# CITY OF ALBUQUERQUE

**RE: Believers Center of Albuquerque – Lobby & Youth Ministry Expansions  
Grading Plan  
Stamp Date: 8/16/17  
Hydrology File: L23D029**

GRADING AND  
DRAINAGE PLAN

CG-101

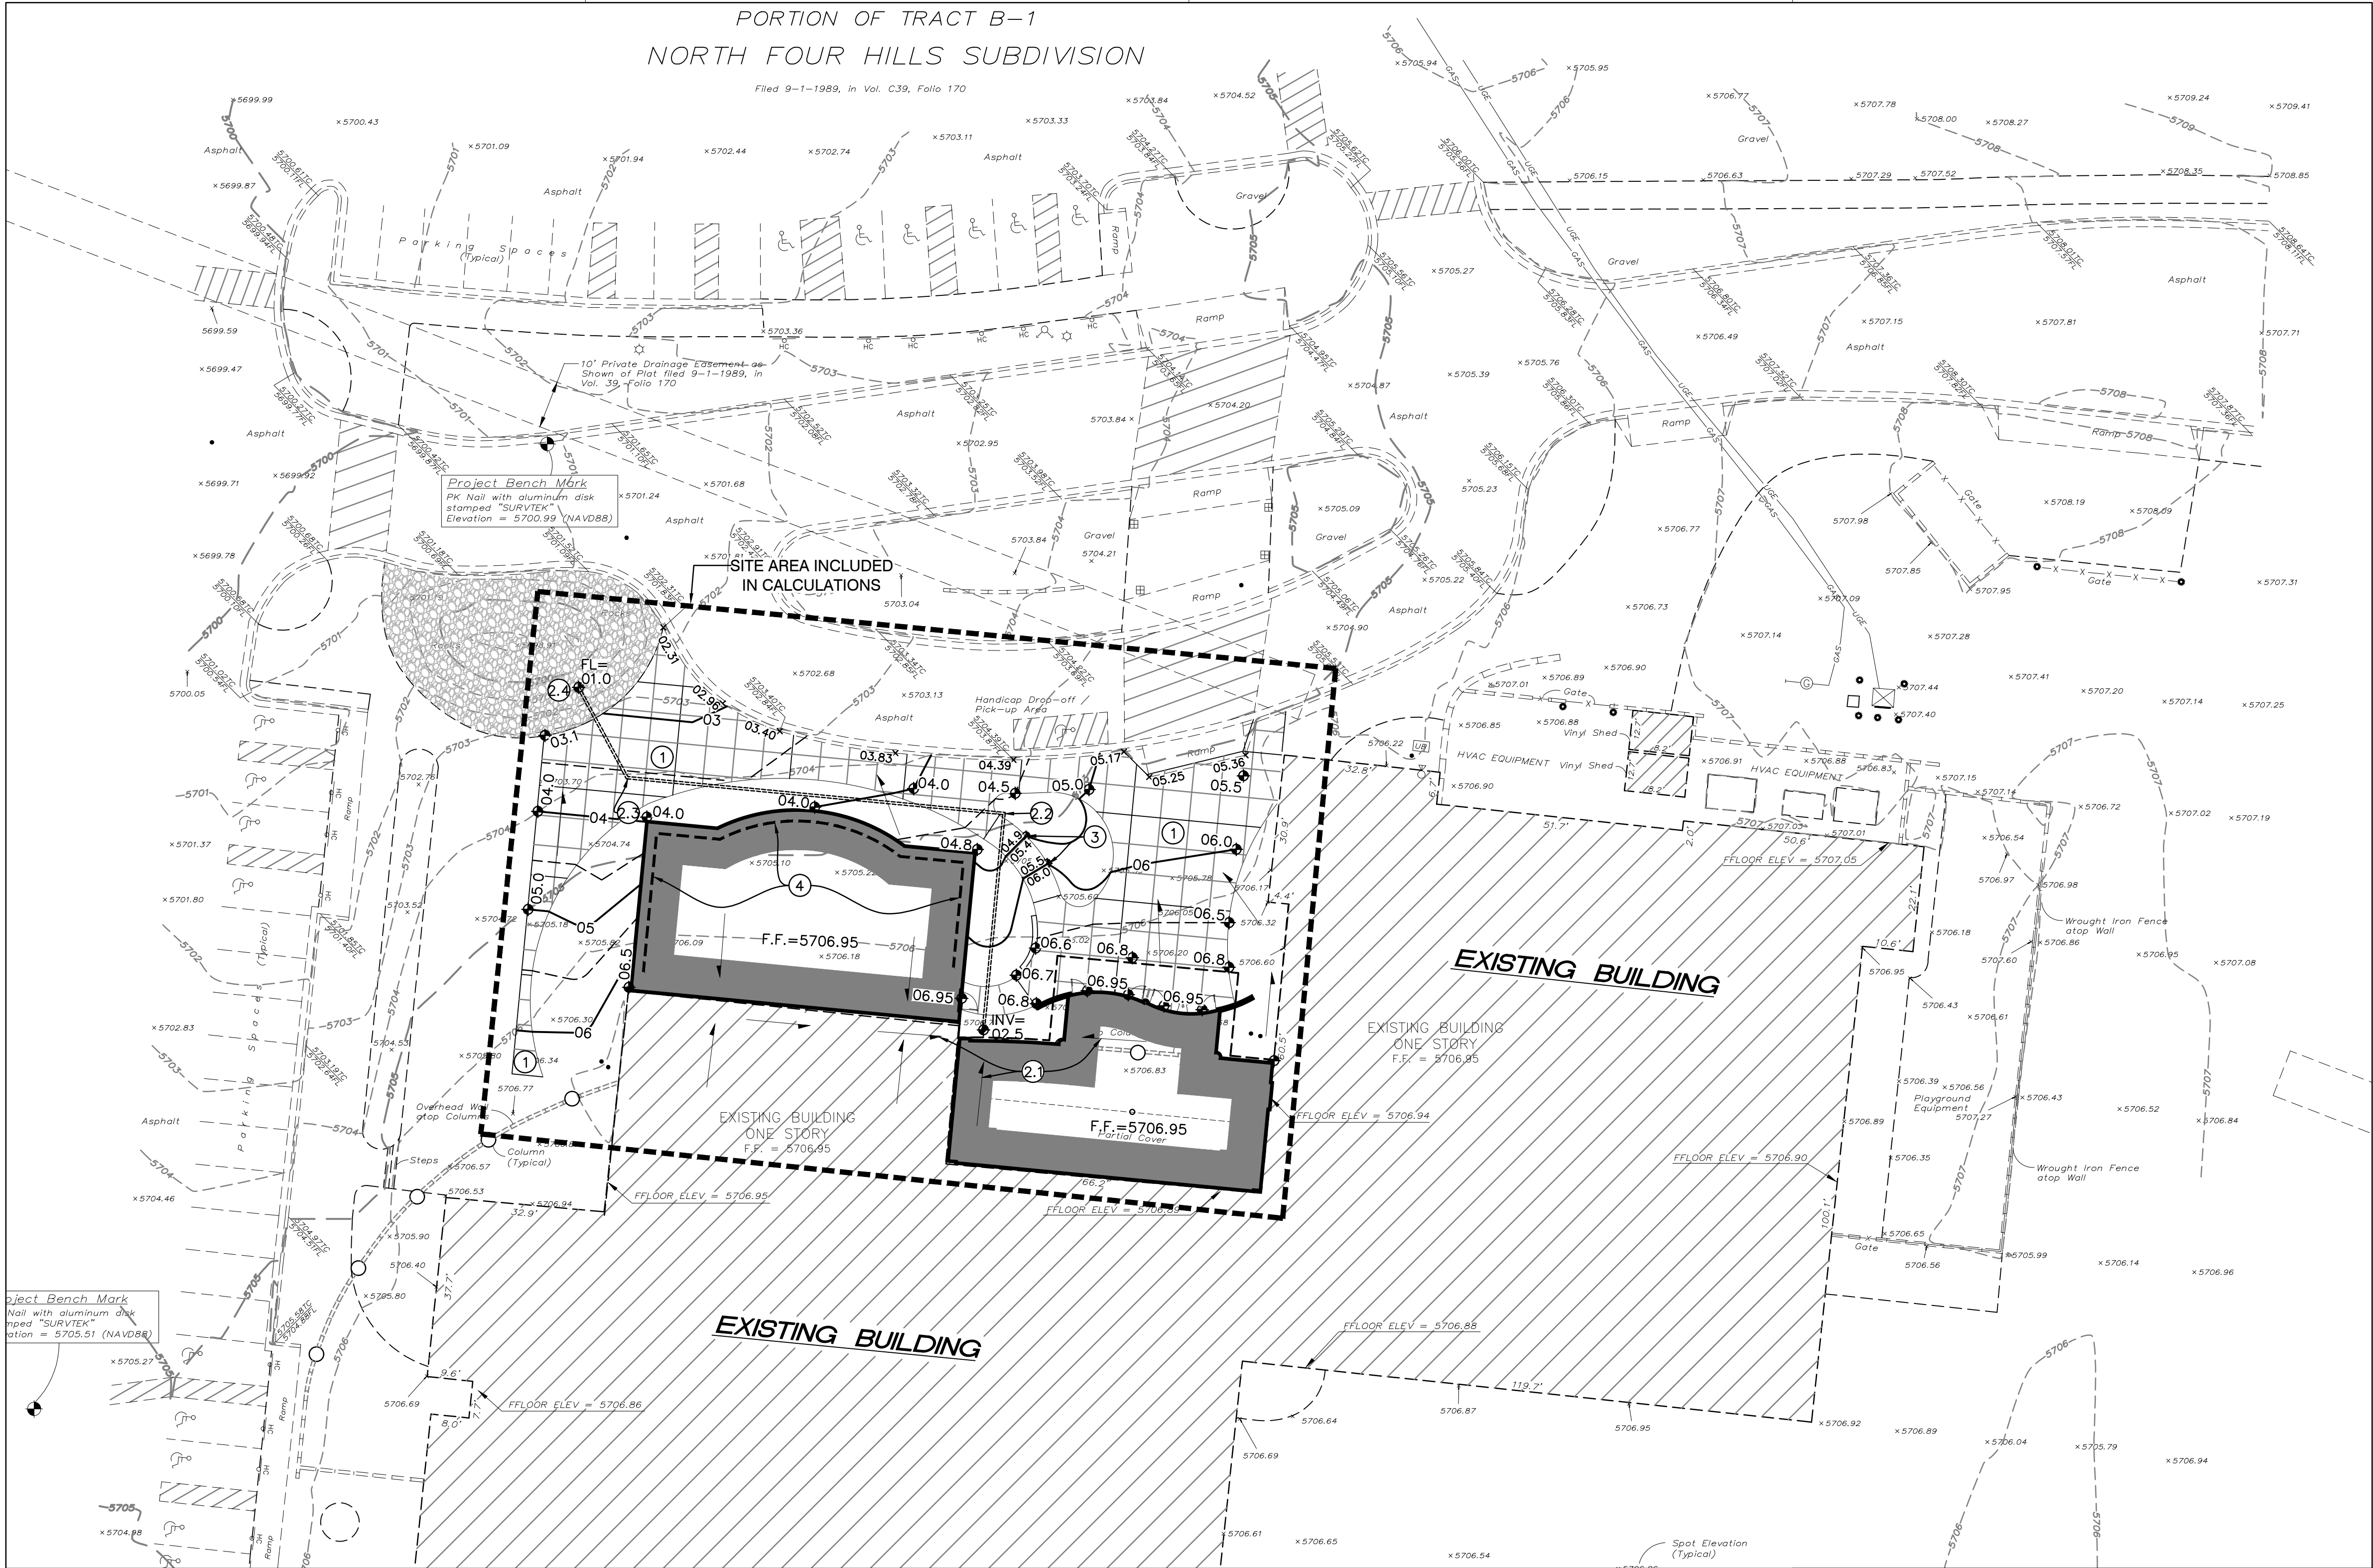
PO Box 1293      Based upon the information provided in your re-submittal received 8/22/2017, the Grading Plan is approved for Building Permit.

Albuquerque      Please attach a copy of this approved plan in the construction sets when submitting for a building permit. Prior to Certificate of Occupancy release, Engineer Certification per the DPM checklist will be required.
